This response to the Romford Road consultation is from **Newham Cyclists**, the local group of the London Cycling Campaign. We are a grassroots volunteer group who exist to help all kinds of people access cycling as a cheap, accessible, and convenient form of transport.

## SUMMARY

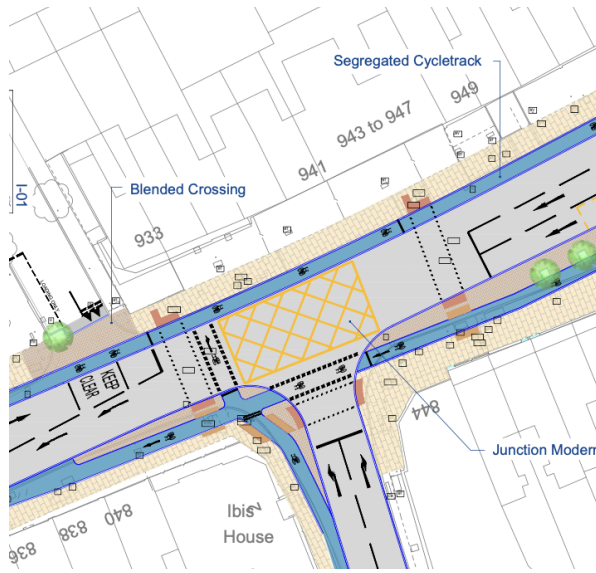
Where	Diagram	Our Comments
Water Lane/Vicarage Road junction		<p><b>Recommendation:</b> Zebra markings should be present on all crossings of the cycle track for consistency.</p> <p><b>In addition:</b> it could be worth exploring a CYCLOPS-style junction with the cycle crossings on the outside of the pedestrian crossings, which would formally allow diagonal pedestrian crossings. On the other hand, such a change might introduce a mismatch with other junctions and result in confusion about who is meant to be where.</p>
